Core Bus Corridor 12: Rathfarnham

16th December 2020

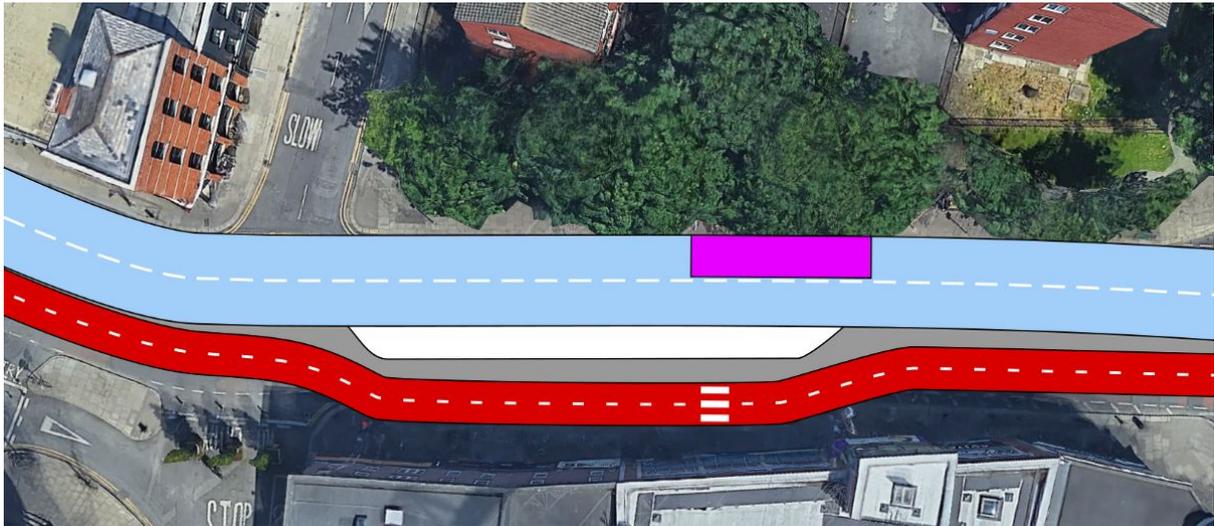
people walking and cycling. With so much on-street parking on nearby roads, plus several multi-storey car parks within a 10 minute walk there is no obvious need for parking bays on Camden Street. One or two of these could be converted into disabled parking, but the rest should be removed or converted into loading bays.

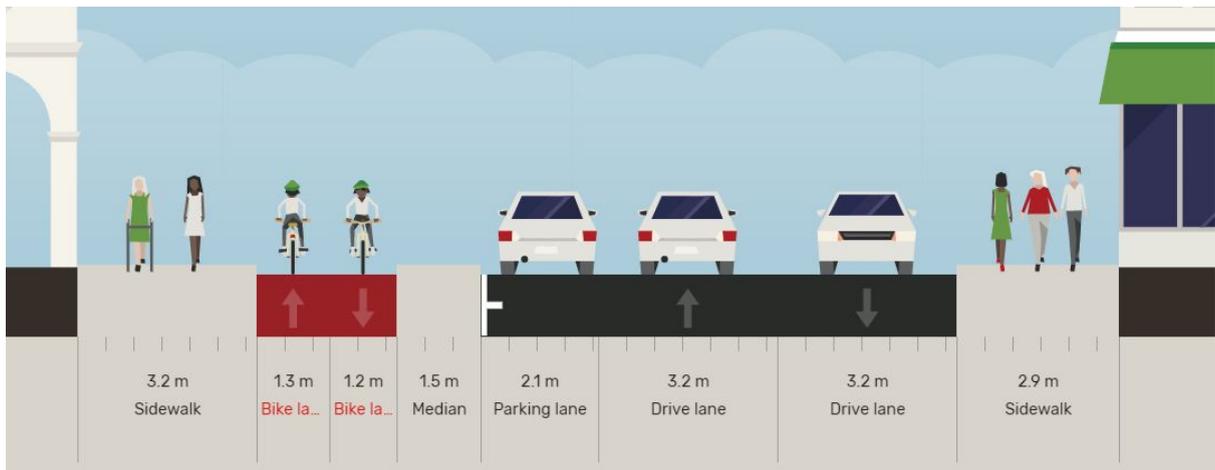
The first graphic is outside Tesco, where the road widens to over 20 m. Without any reduction in footpath width or loading bay length, it is easily possible to install a 6.5 m wide carriageway, a 3 m wide bidirectional cycle path, a 2.1 m wide loading bay, and a 1.5 m buffer between the loading bay and cycle path.
